Central Falls High School

100% Construction Documents

Ai3 Project #2202.02

Addendum #7

DRAWING NAME:
EXISTING CONDITIONS AND DEMOLITION PLAN
 DRAWN BY: SMC
 REVIEWED BY: GBD
 SCALE: AS NOTED | DRAWING NUMBER:
 JOB NO.: 77977
 DATE: OCTOBER 13, 2023
C1.0

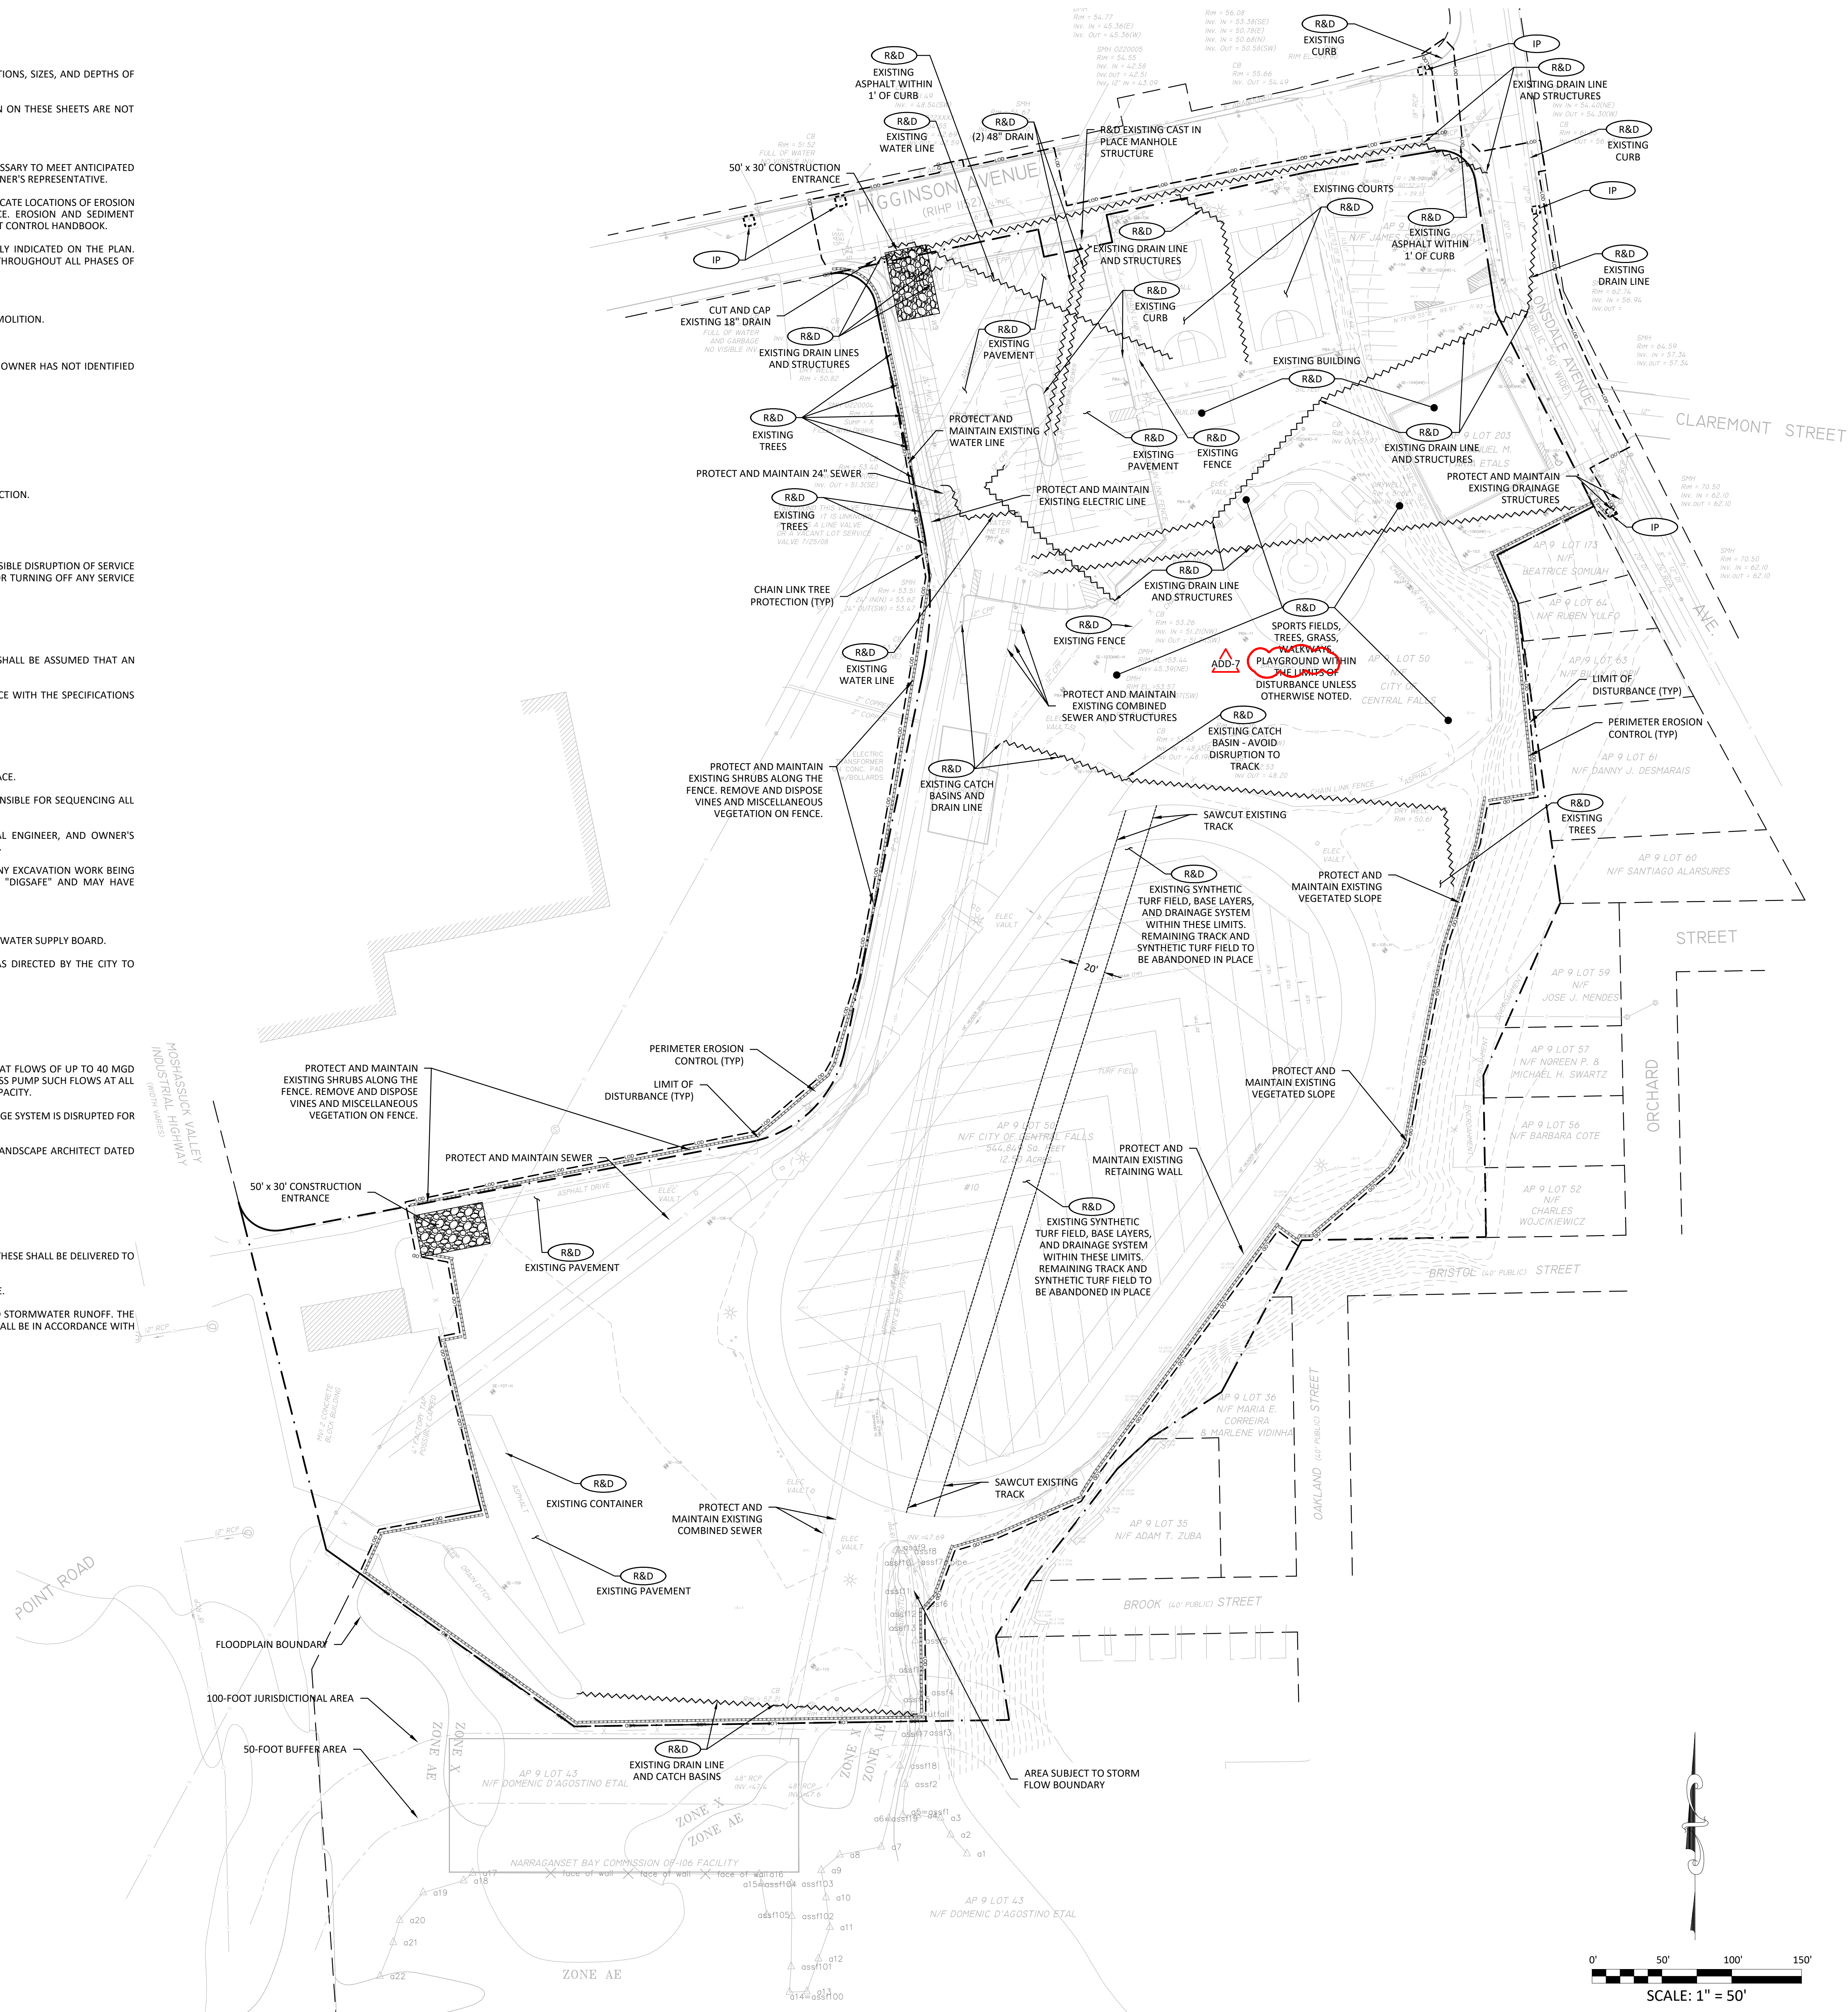
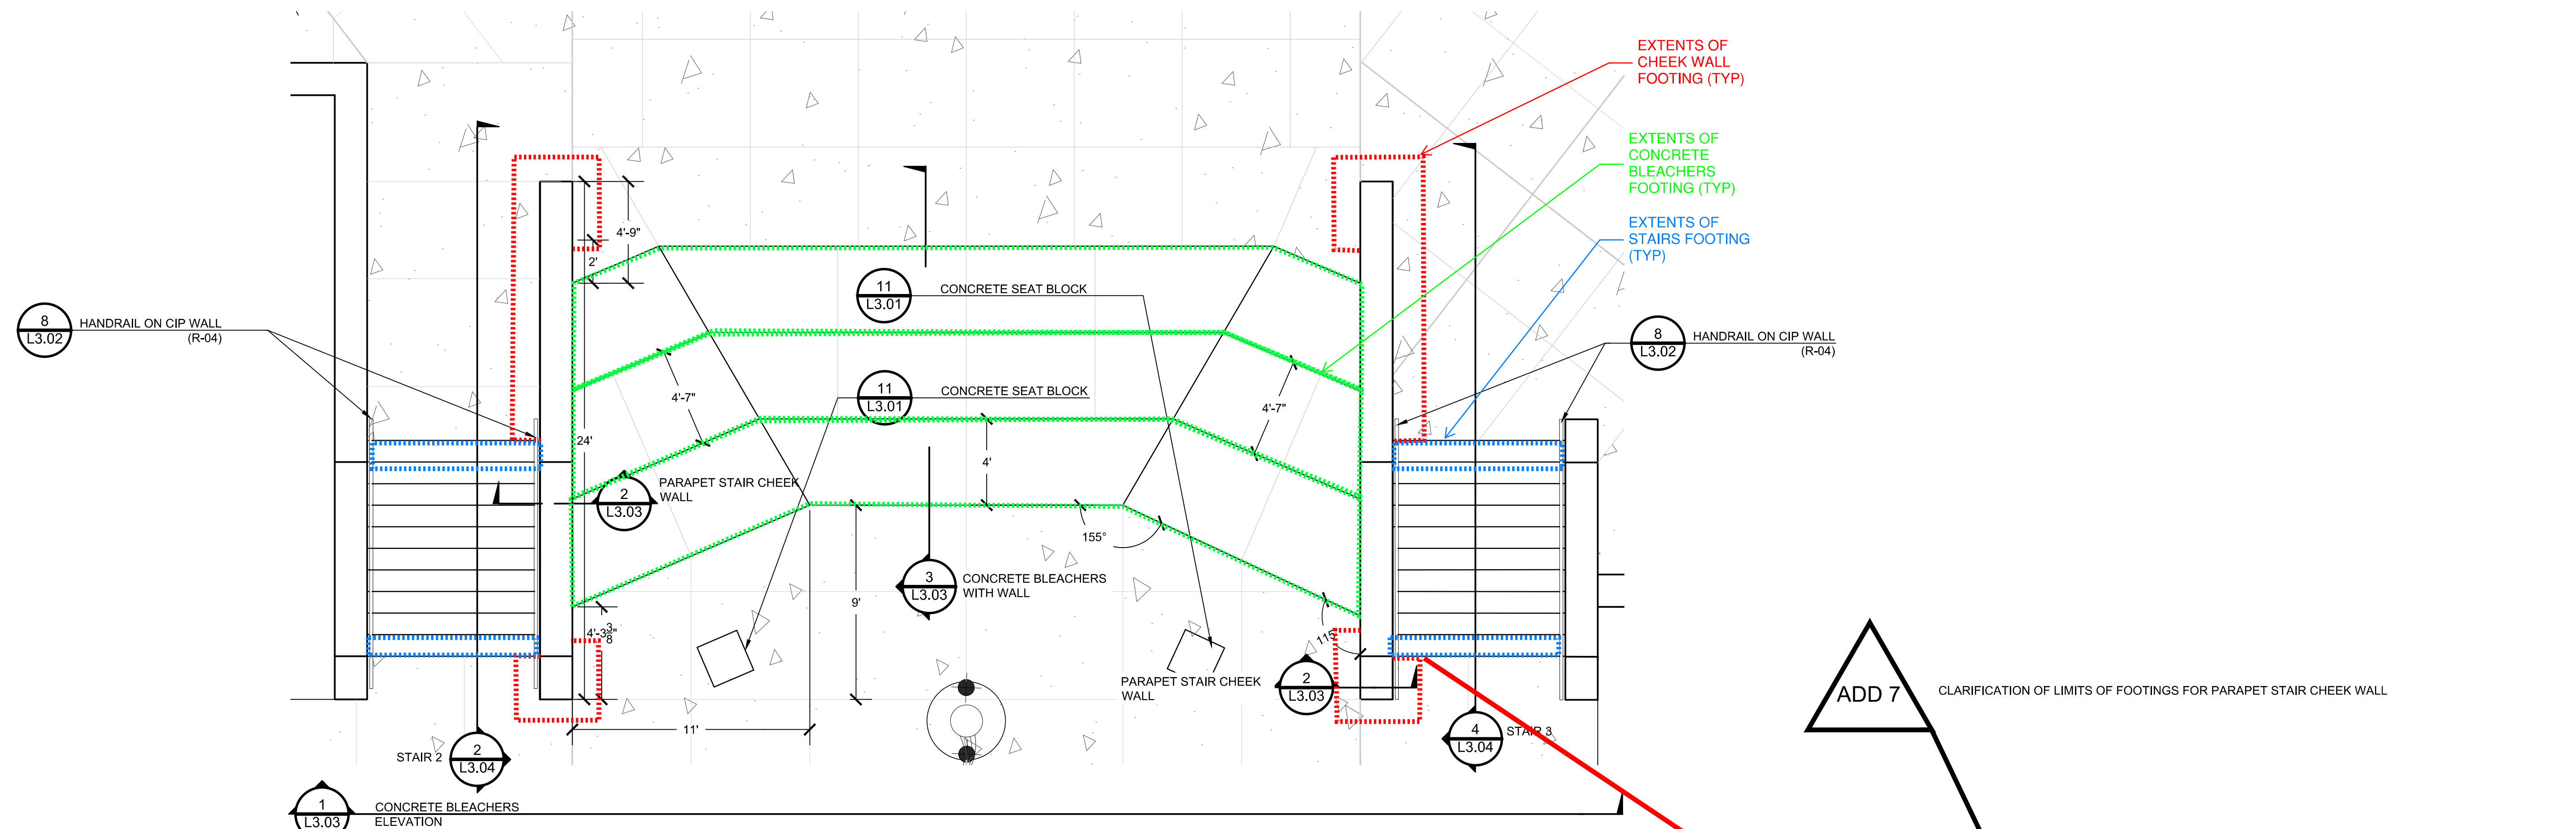
- ADD 7-002** **Bidder Question:** At the site walk we observed there to be an existing playground, NW of the existing track. Please confirm the General Contractor is to R&D this playground and equipment as part of their work. **Response:** The City will not remove or salvage the playground. The City has already removed everything they wanted to save from the complex. It is the General Contractor's responsibility to remove and dispose of the Playground Equipment. Refer to attached drawings.
